Central Subpopulation of Northern Anchovy

STAR Panel Meeting Report

Online
December 7-10, 2021

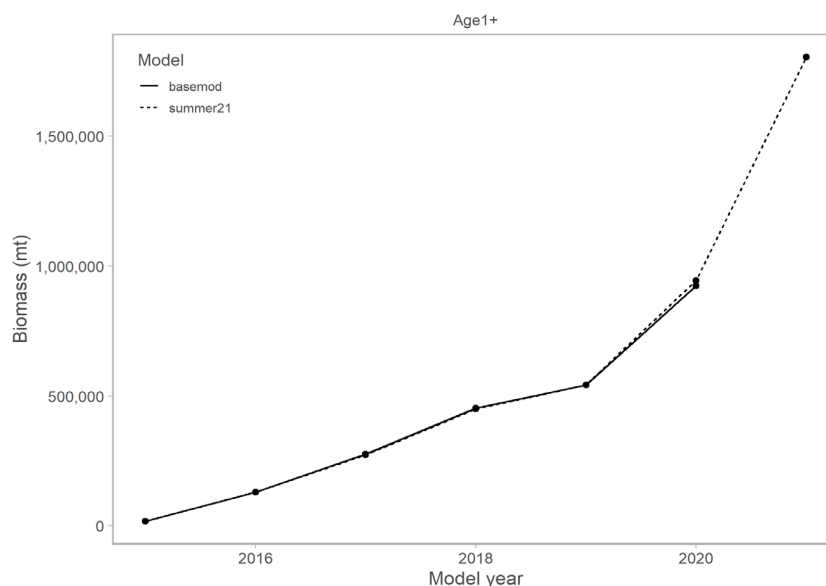
Request 10: Same as Request 9, but also include the preliminary results from the summer 2021 AT survey with $Q=1$.

Rationale: Similar to Request 9, plus the summer 2021 AT survey extended into Mexico, implying complete latitudinal coverage.

Response: The base model forecasts age-0+ biomass for June 2021 to be 2.26 million mt and 1.59 million mt for age-1+. The preliminary biomass estimate from summer 2021 AT cruise was 2.357 million mt, CV=0.15 (and no age compositions yet). This model has an additional year in the model time period.

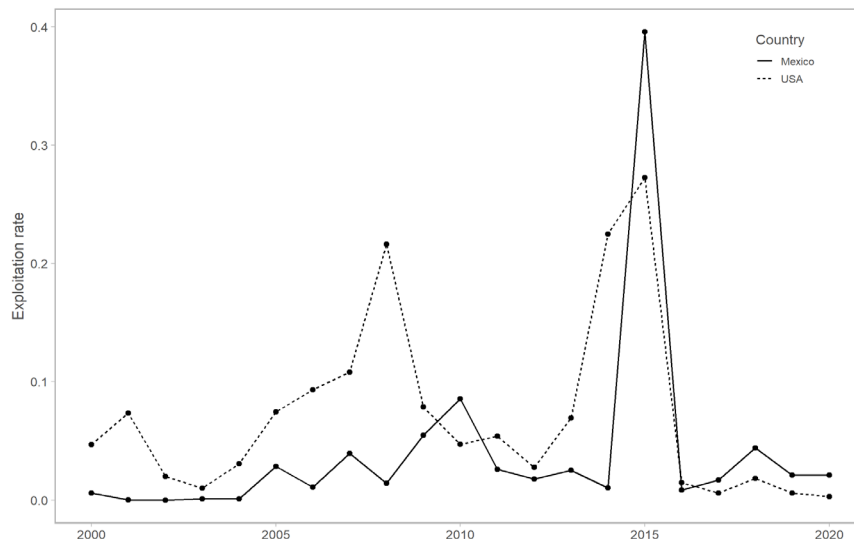
Request 11: Convert plots of F through time to exploitation rate for the extended RREAS model, similar to Figures 34 versus 35 of the draft assessment document.

Rationale: Some “unreasonably high” F values may reflect very low modelled selectivity on the age classes predominantly available to the fishery in a particular year, and the base model included some similarly high (or higher) F estimates.

The Panel noted that the exploitation rates were generally low (< 5% for most years and fleets) with the notable exception of 2015, which had similarly high exploitation rates in the base model,

and appears to be a year of rapid biomass increase that may not be well reflected by using June 1 biomass as the denominator in the exploitation rate calculation.

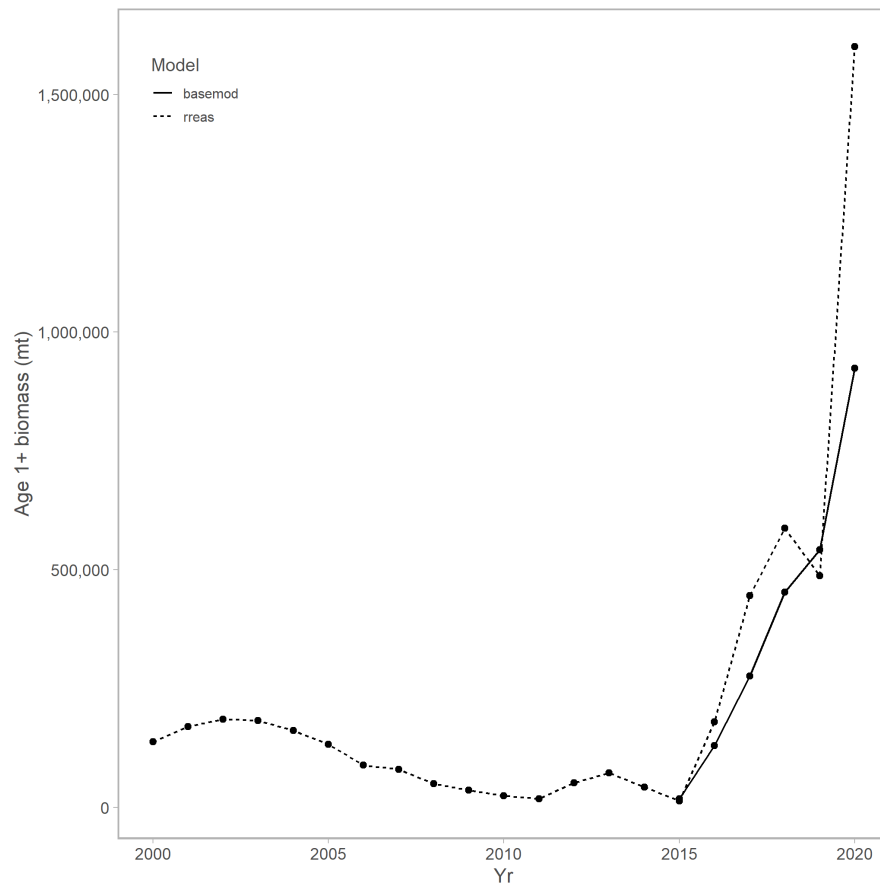
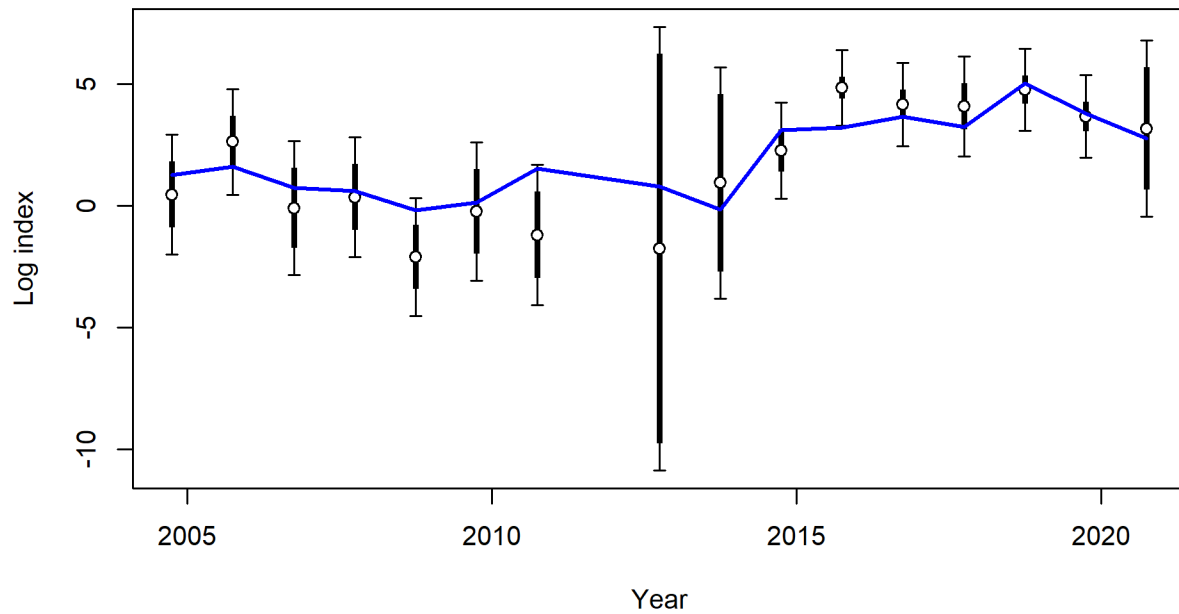
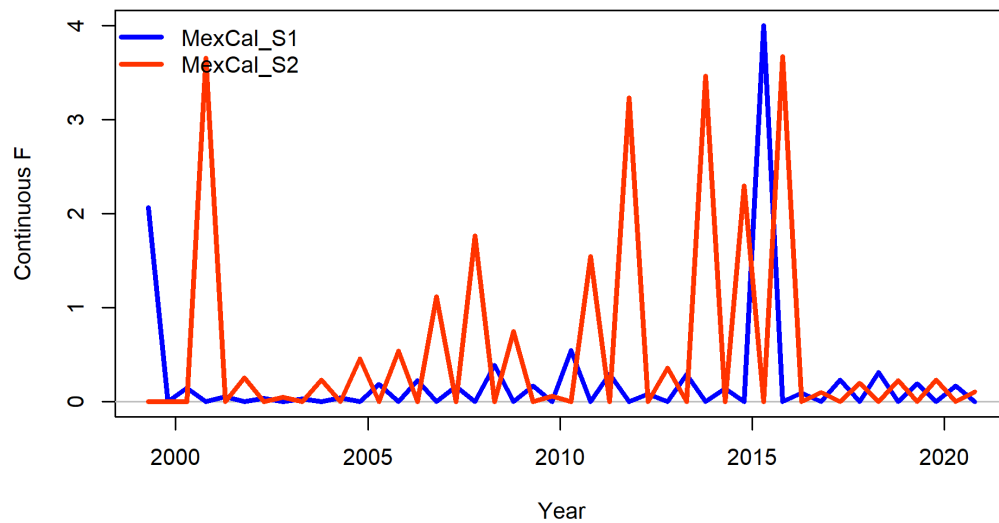
Request 12: Provide r4SS outputs for the draft base model and for the extended RREAS model to investigate patterns in F , exploitation rate, selectivity, and how well the modelled recruitments fit the RREAS recruitment index.

Rationale: The Panel wished to better understand the changes in fit when the RREAS YOY index is included and the model timeline is extended.

Response: The plots were provided and the Panel continued to use r4ss to examine model fits, outcomes and parameter values.

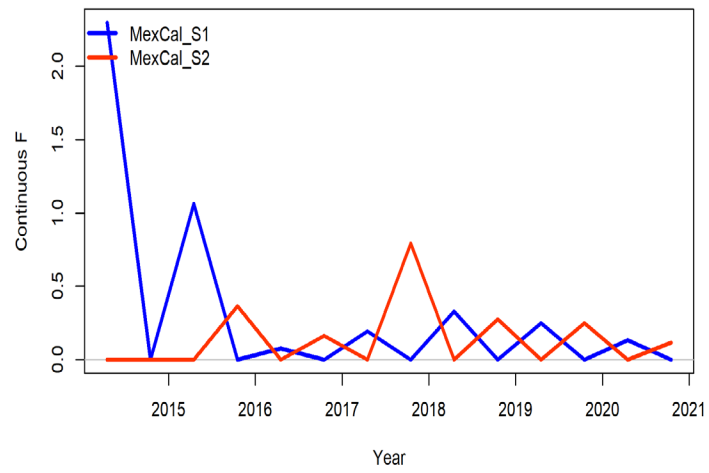
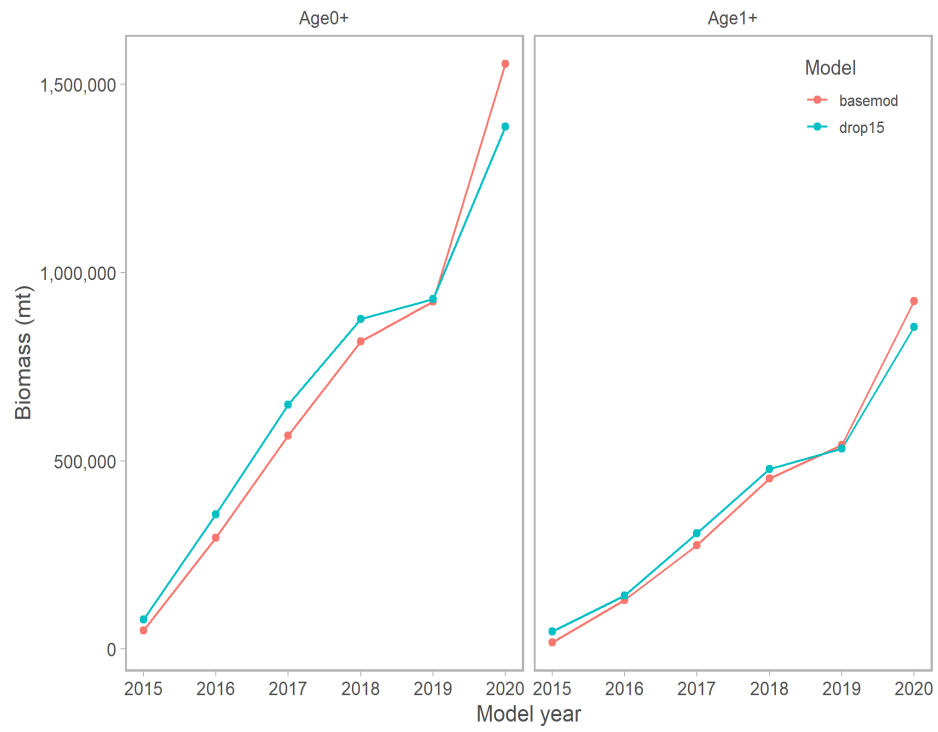
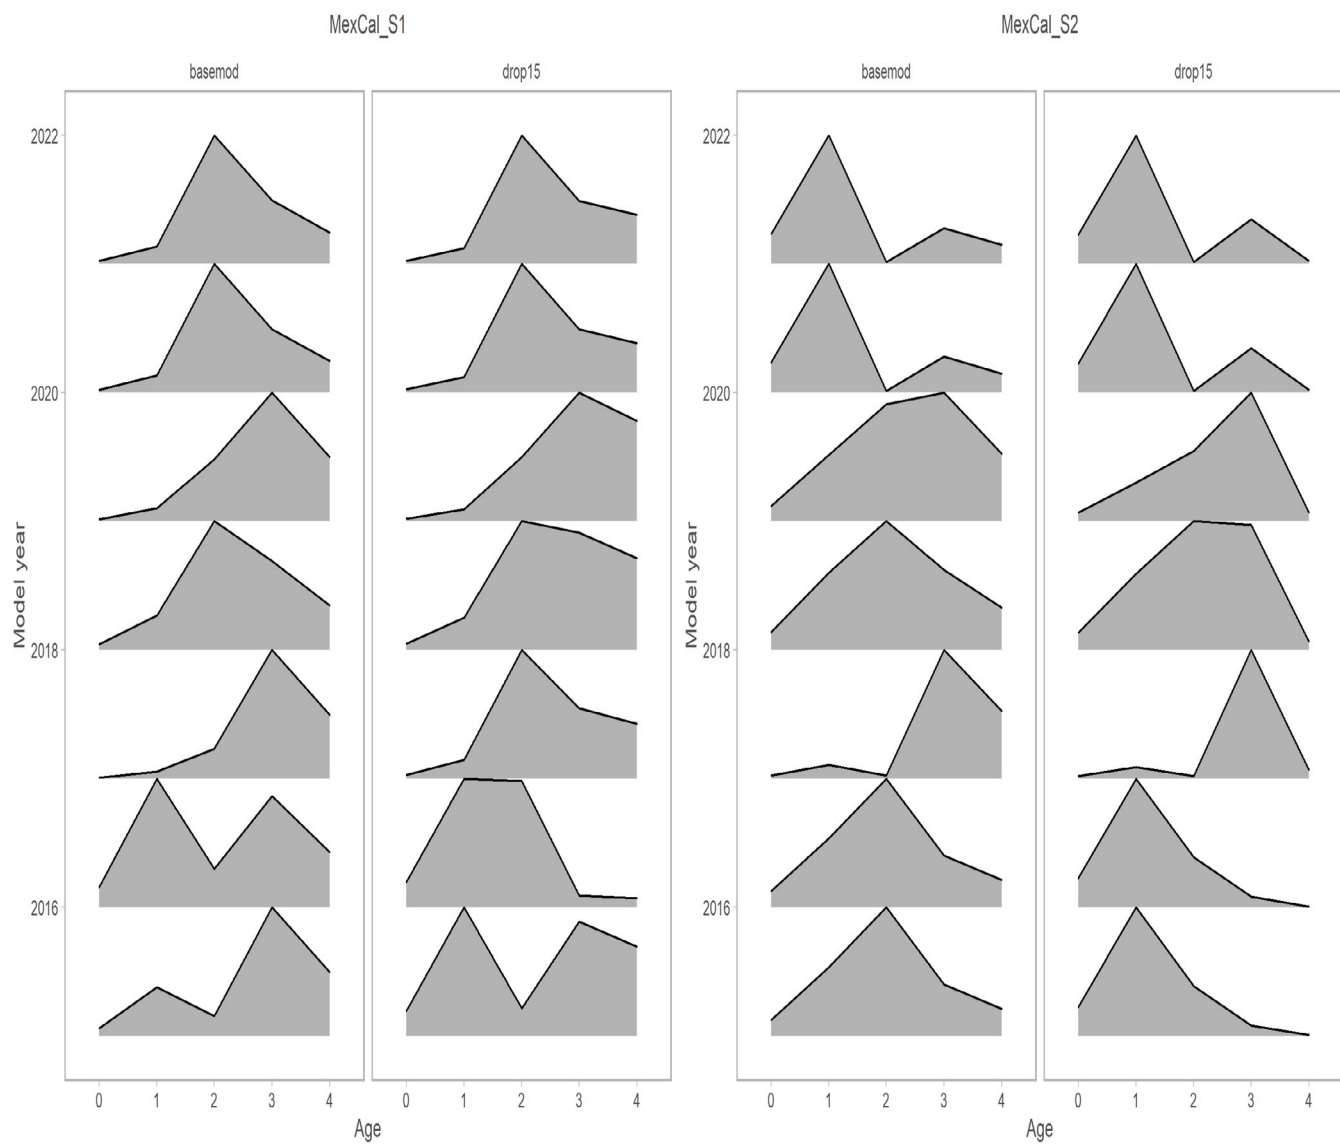
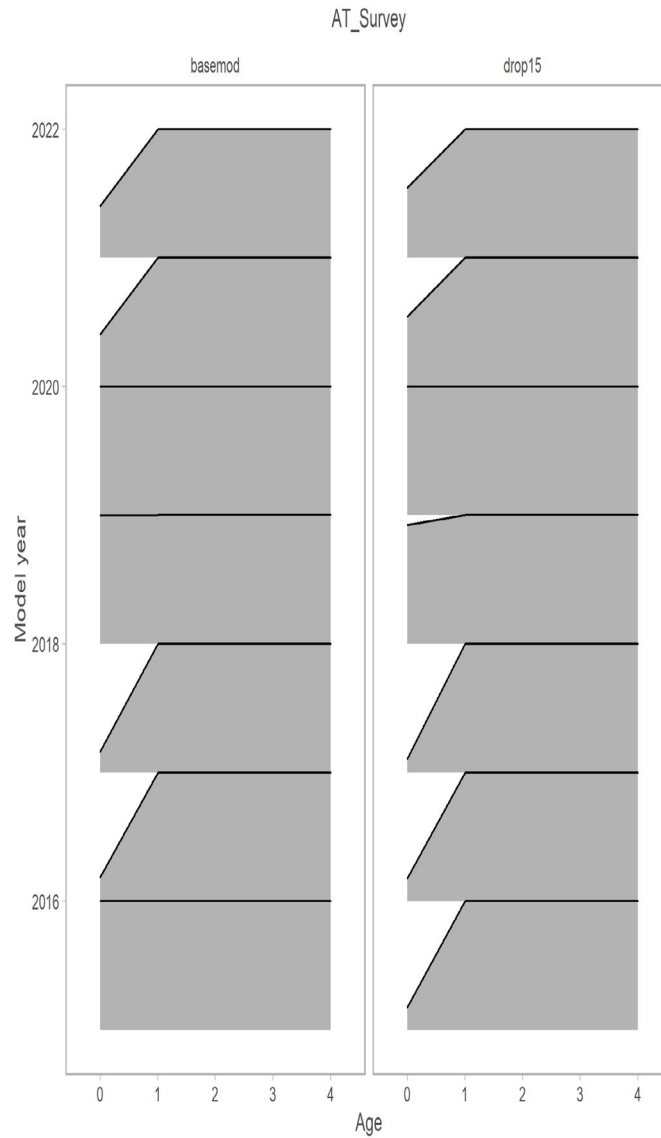
Request 13: As a sensitivity analysis, re-run the base model excluding the 2015 AT survey.

Rationale: The 2015 AT survey may be less reliable than more recent AT surveys for the purpose of estimating CSNA biomass.

The results of the run with no 2015 survey (index or age-composition) were qualitatively nearly identical to those for the original base model.

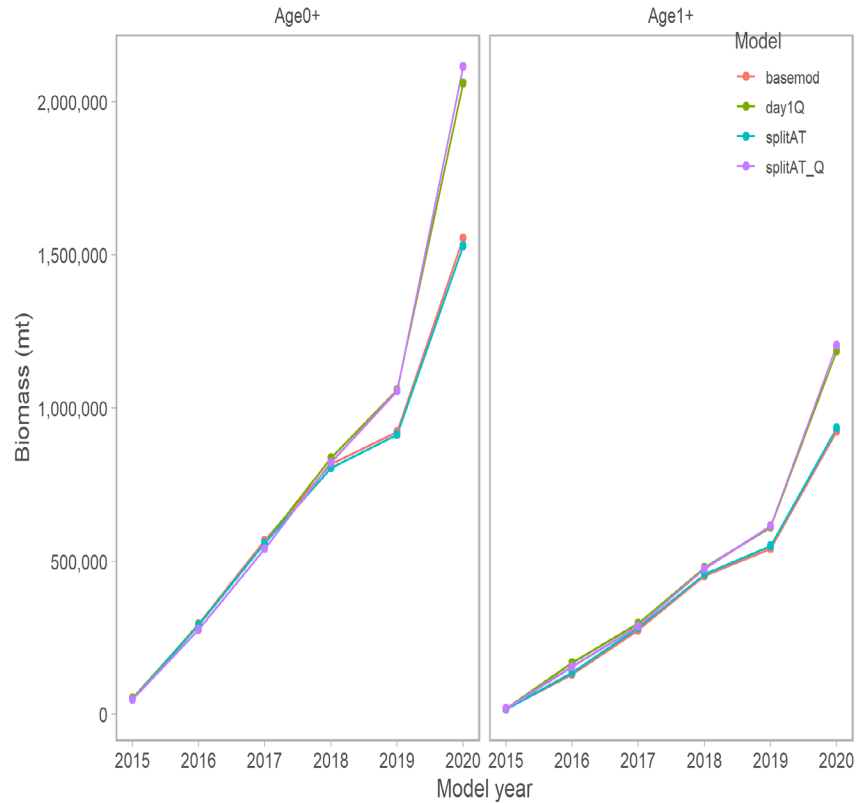
Request 9a: Similar to Request 9, but use separate Qs for the AT spring versus summer surveys in 2016. This can be done by treating the spring and summer AT surveys as separate fleets.

Rationale: Same as Request 9, noting that it is more time consuming to set up a model that allows for different Qs for the spring versus summer AT surveys in the same year and so this was not done in the initial response to Request 9.

Response: The plot below shows the biomass values with the AT survey treated as two separate fleets, each with their own Q values. The “splitAT” scenario is the base model with two AT fleets.

Figure 5: Spatial distribution of young-of-the-year (YOY) anchovy catches, 2004-2021

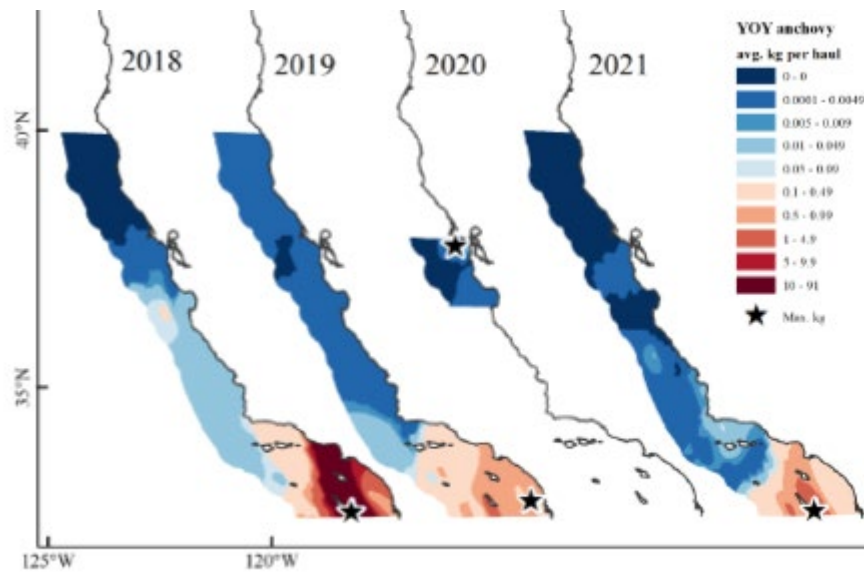
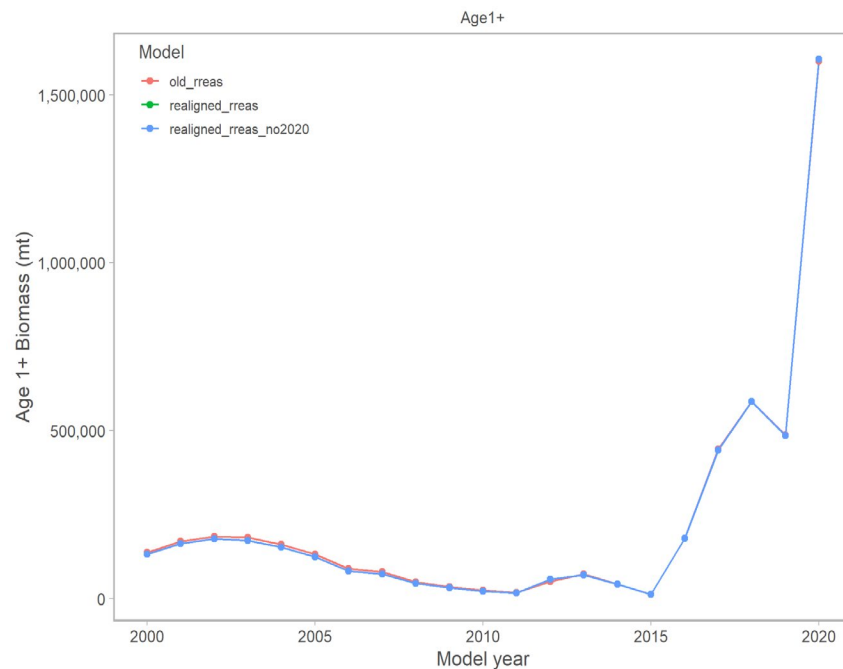
Request 15 (STAT-initiated): Re-run the extended RREAS model with a fix to the timing assigned to the AT survey in the model, with and without the 2020 index, and using a larger upper bound on M (1.5yr^{-1}).

Rationale: It was noted that the timing was incorrect in previous versions of the model with the RREAS index. The STAT also suggested dropping the 2020 RREAS index value because of very limited spatial coverage. The surveys occur in May, generally after the spring AT survey and before summer AT survey. Consequently, for example, the May 2015 RREAS should be input as a recruitment index input to the model at June 1 during model year 2016. The RREAS base model is “realigned_reas_no2020” in the figure below.

The Panel agreed that dropping the 2020 (as well as 2011, which also had low spatial coverage and was dropped from all runs under consideration) estimate from the index was appropriate.

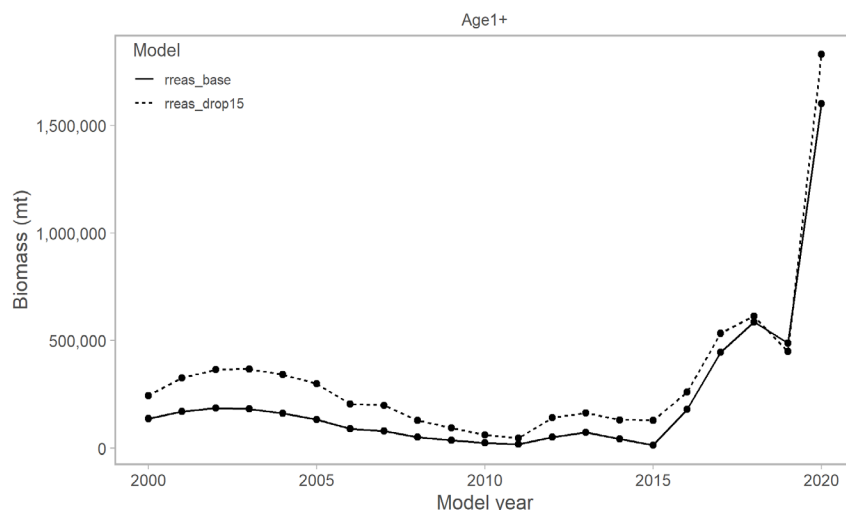
Request 17: Provide a run of the extended model including the RREAS, but excluding the 2015 AT survey.

Rationale: The 2015 AT survey may be less reliable than later AT surveys for the purpose of estimating CSNA biomass.

The revised model showed that excluding the 2015 AT survey increased biomass (as expected). It was noted that the estimate of M hit its upper bound (initially set to 1.0 yr^{-1}), which led to request 27. In a re-run of this model that increased the M boundary to 1.5 yr^{-1} , M was estimated as 1.06 yr^{-1} .

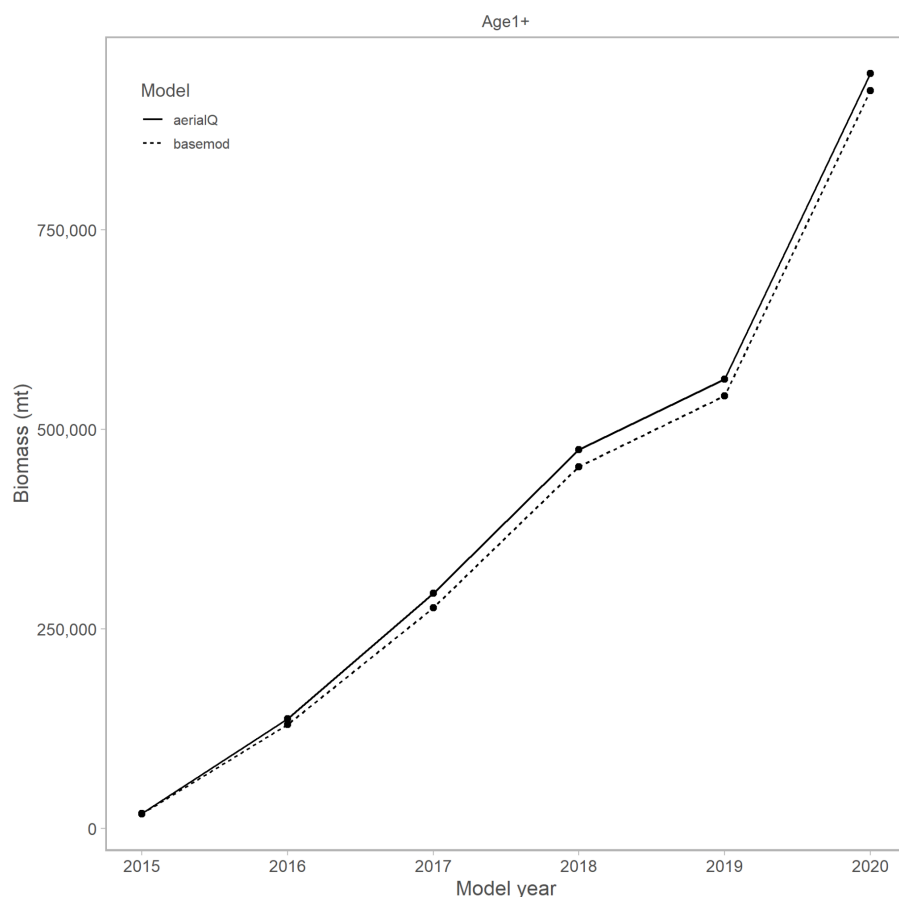
Request 20: Conduct a sensitivity analysis using alternative values for the AT survey catchability Q informed by the estimates of the proportion of biomass observed by the aerial survey inshore of the AT survey.

Rationale: The AT survey is constrained by the draft of the vessel preventing access to the most nearshore waters where CSNA are commonly observed, resulting in their omission from the survey estimates. This analysis is intended to use aerial survey data to inform catchability, accounting for the proportion of the abundance unaccounted for in the area shoreward of the AT survey.

As expected, there was little impact on estimates of age-1+ biomass by accounting for inshore corrections.

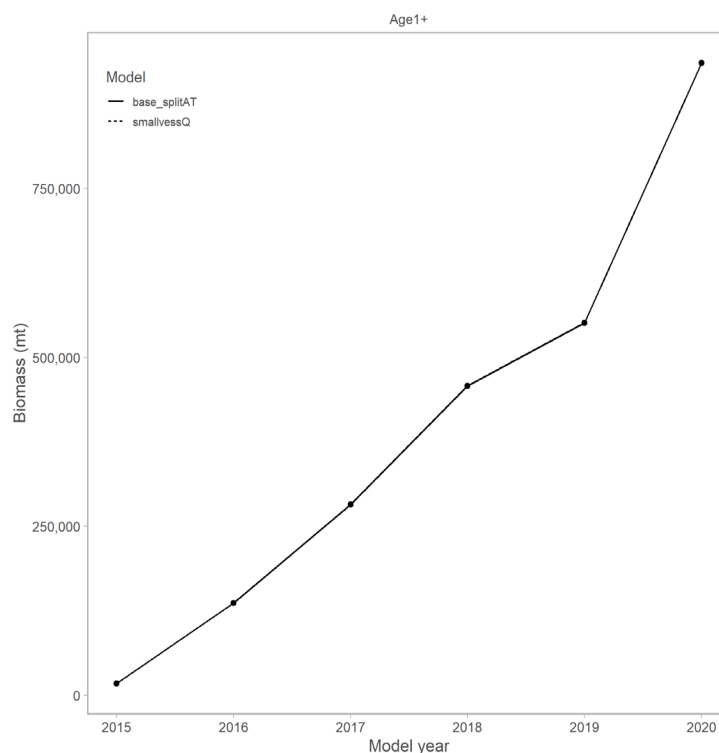
Request 21: Conduct a sensitivity analysis using alternative values for the AT survey catchability Q informed by the estimates of the proportion of biomass observed by small vessel acoustic surveys inshore of the AT survey.

Rationale: The AT survey is constrained by the draft of the vessel, preventing access to the most nearshore waters where CSNA are commonly observed, resulting in their omission from the survey estimates. This analysis is intended to use small vessel acoustic survey data to inform catchability, accounting for the proportion of the abundance unaccounted for in the area shoreward of the AT survey.

Response: A table was created with the fraction of the biomass estimated nearshore, and used to inform Q , producing the following biomass trajectory. Surveys are coded as YYMM, i.e. 1507 corresponds to summer (July) 2015.
